TOPIC: BLEND UNIFORMITY

FDA/CDER Review of the PQRI Recommendations on Blend Uniformity Analysis

FDA/CDER Comments

Document: "Results of Statistical Analysis of Blend and Dosage Unit Content Uniformity Data Obtained from Product Quality Research Institute Blend Uniformity Working Group Data-Mining Effort"

**Content Uniformity Data
on Tablets (Prod. D, Comp. X)**

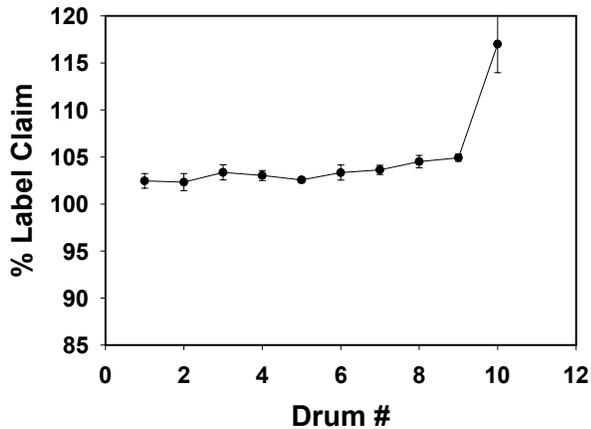
(b) As stated above, the PQRI proposal has the potential to improve detection of post-blending particle segregation that can occur with certain powder blends. Ideally, development and validation efforts would eliminate such blends or correct the problem. In a few cases such problems may not be apparent at the time of process validation. Segregation problems may creep in during routine production due to reasons such as variations in physical attributes of raw materials (that may comply with compendial specifications and other qualification criteria). When particle segregation occurs following blending operation, a stratified sampling of dosage unit may be more effective than conventional blend uniformity analysis plus compendial dose uniformity tests conducted on a few randomly collected samples. An example, discussed at the ACPS meeting (<http://www.fda.gov/ohrms/dockets/ac/01/transcripts/3804t1.doc> page 170), of such a case is illustrated below. A commercial product that meets blend uniformity (RSD <1%) and USP dose content uniformity Stage I specifications, exhibits a non-random trend (possibly due to segregation) towards the end of the production run that was detected using a stratified sampling protocol.
